From: Juan Baeza
Sent: 01 December 2021 10:55
To: Hannah Riddle
Subject: FW: Tudor Close

From: Phil Rowe [REDACTED]
Sent: 01 December 2021 10:45
To: Ben Kirk [REDACTED] Mike Dean [REDACTED]
Cc: Juan Baeza <Juan.Baeza@arun.gov.uk>
Subject: Tudor Close

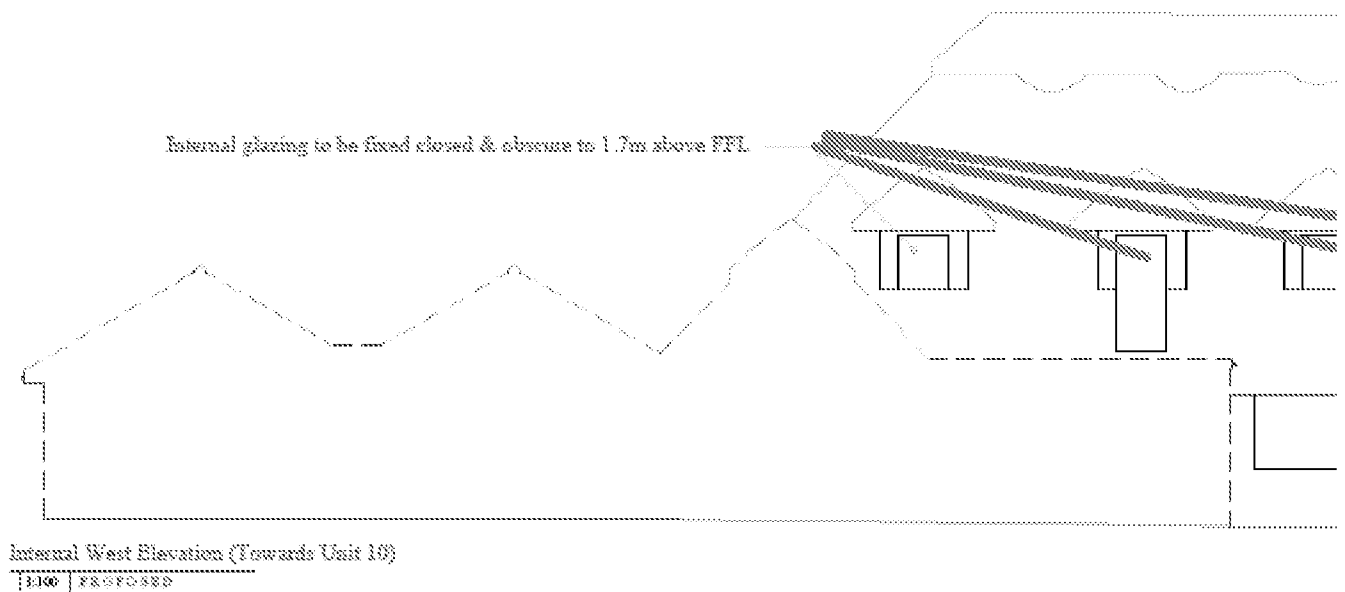
We are going to stick with the originally proposed dormers. Can you please amend the plan below to confirm all of the proposed dormers will have fixed close and obscure to 1.7 above FFL.

This will prevent any overlooking.
